February 24, 1984
LIC-84-057

Statistical Combination of Uncertainties Report
Fort Calhoun Station Unit No. 1

ATTACHMENT

FIGURE 1

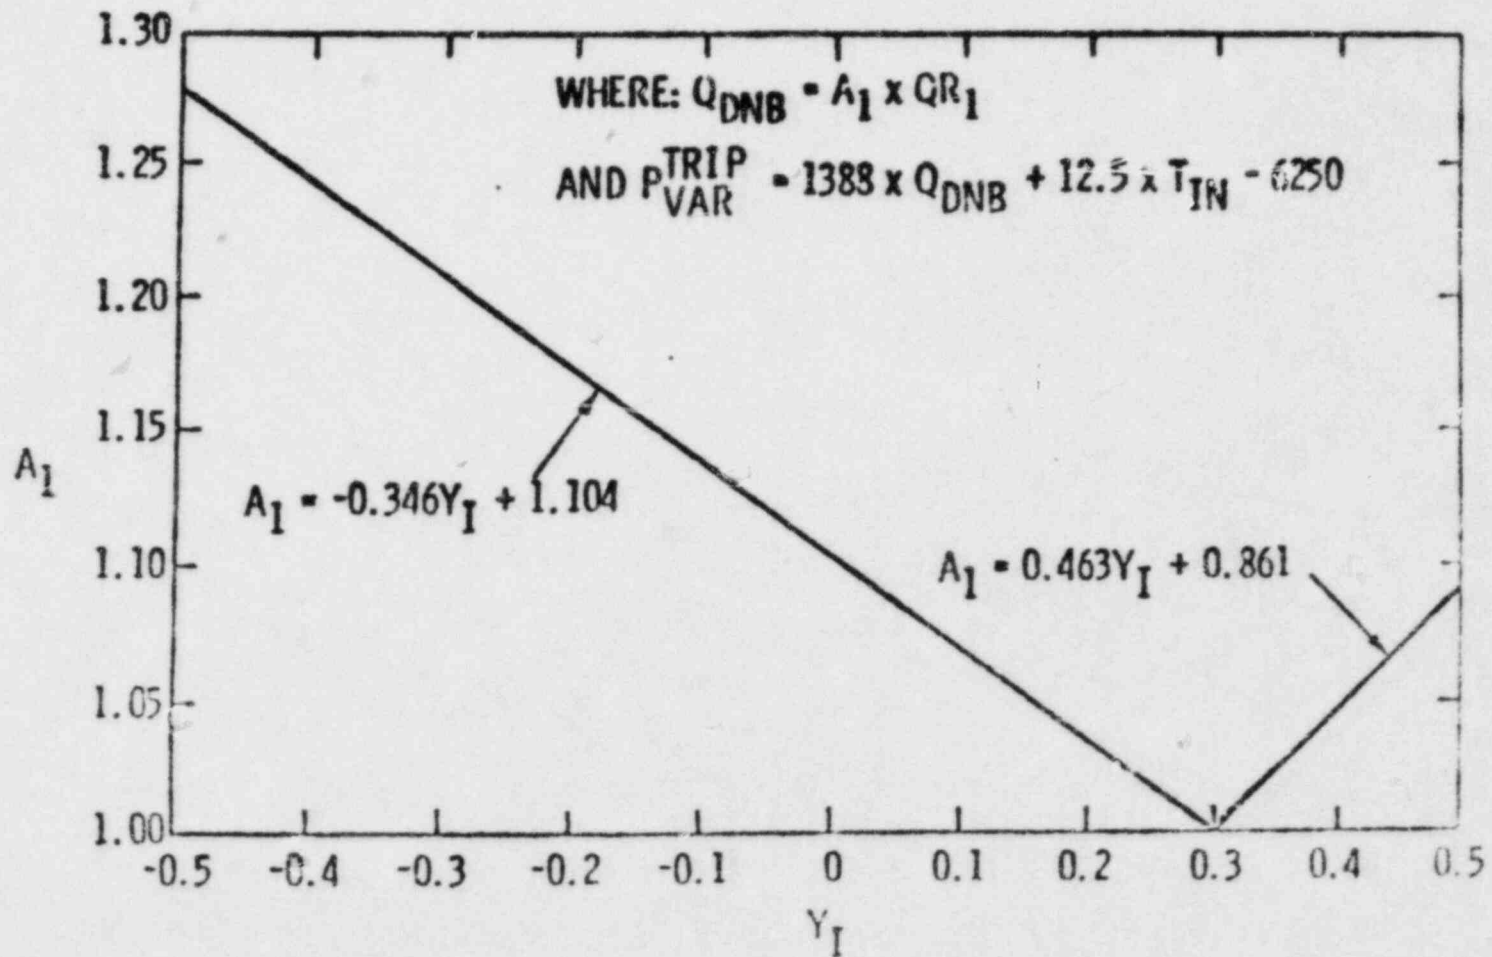
Section 2.2 of Part 1 of the report indicates that the minor changes in the analytical technique (used to evaluate the uncertainty factors for other CE plants employing analog reactor protection systems) have been made to accommodate the earlier generation RPS in use at Fort Calhoun. (a) What are the differences between the Fort Calhoun RPS and that used at Calvert Cliffs and St. Lucie? (b) What are the changes in the analytical technique to accommodate the differences? (c) What are the differences between the CESCUC stochastic simulation methodology and that used for Calvert Cliffs and St. Lucie?

1. The TM/LP trip at the Calvert Cliffs and St. Lucie units uses the following equation:

- P_{var} = variable low pressure trip limit.
- $A1$ = a function of measured ex-core ASI (see Figure 1).
- $QR1$ = a function of measured core power (see Figure 2).
- T_{in} = measured coolant inlet temperature.
- α, β and γ = preset constants.
